**Planning Department  
Transportation Development Services**

**Re: Bella Vista Assisted Living  
13101 Constitution NE  
Traffic Circulation Layout**  
Engineer's/Architect's Stamp dated 5-12-15 (J22-D067)

BELLA VISTA ASSISTED LIVING  
PROPOSED SITE PLAN  
ALBUQUERQUE, NM  
PROJECT #1410

SHEET NUMBER  
CA-1.0

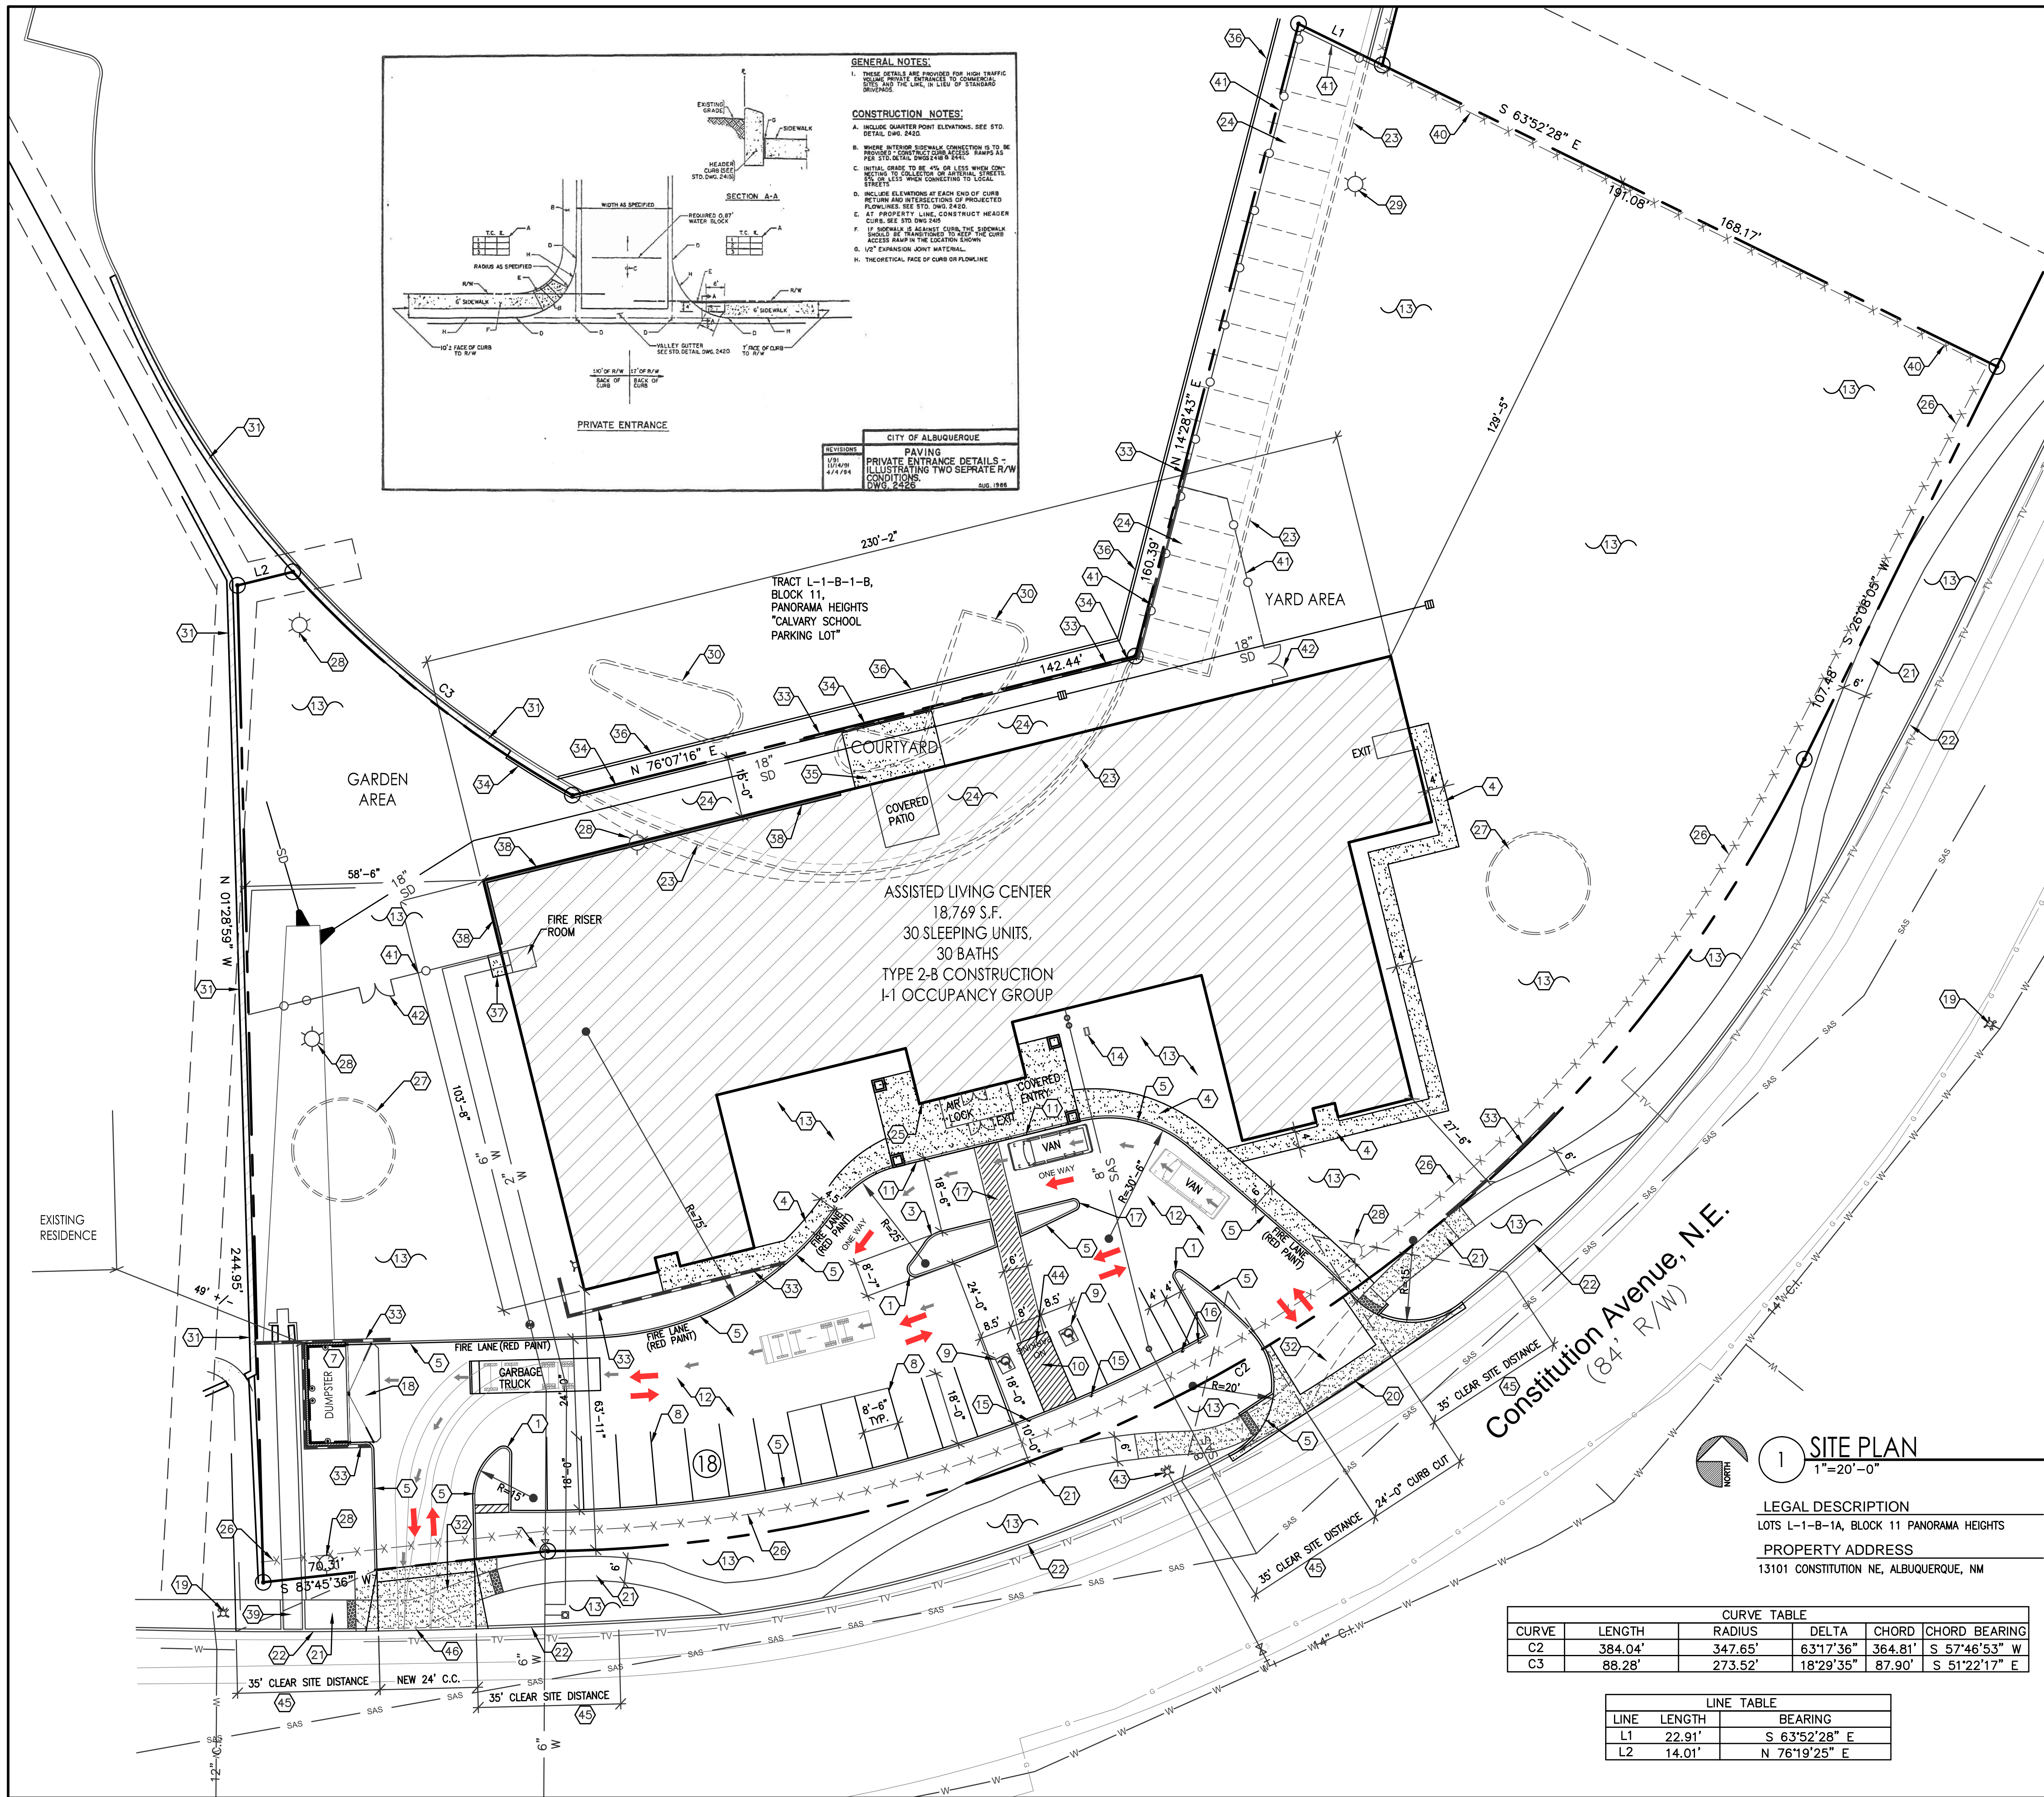
1. Per the Development Process Manual, Chapter 27 Drafting Standards, "Standard sheets must be 24" by 36" having a margin of 2" along the left and 1" on the top and bottom."

2. The ADA van accessible sign must have the required language per 66-7-352.4C NMSA 1978 **"Violators Are Subject to a Fine and/or Towing."**
3. The ADA access aisle shall have the words **"NO PARKING"** in capital letters, each of which shall be at least one foot high and at least two inches wide, placed at the rear of the parking space so as to be close to where an adjacent vehicle's rear tire would be placed. (66-1-4.1.B NMSA 1978)

4. Per the DPM, a 6 ft. wide ADA accessible pedestrian pathway is required from the public sidewalk to the building entrances. Please clearly show this pathway and provide details and dimension for sidewalks and crosswalks.

5. Per the DPM, a 6 ft. wide ADA accessible pedestrian pathway is required from the HC parking stall access aisles to the building entrances. Please identify and dimension pedestrian pathway to all entrances and exits, also for sidewalks and crosswalks.

6. Design delivery vehicle route needs to be shown.
7. Service vehicle and/or refuse vehicle maneuvering must be contained on-site; provide a copy of refuse approval (if applicable).

8. Please provide a sight distance exhibit for each entryway off of Constitution Ave. (see the *Development Process Manual, Chapter 23, Section 3, Part D.5 Intersection Sight Distance*).

9. Please add the following note to the clear sight triangle: "Landscaping and signage will not interfere with clear sight requirements. Therefore, signs, walls, trees, and shrubbery between 3 and 8 feet tall (as measured from the gutter pan) will not be acceptable in this area."
10. Work within the public right of way requires a work order with DRC approved plans.
11. Label red paint for curb along fire lane.
12. Show doorways to proposed new building.
13. Call out COA standard drawing numbers applicable for work done within COA Right-Of-Way including COA Standard Drawing 2425 for drive pads and 2426 for private entrances.
14. Provide curb ramps for private entrance on the east side of proposed building and provide detail of curb ramp, include detectable warning surface.
15. Please include two copies of the traffic circulation layout at the next submittal.
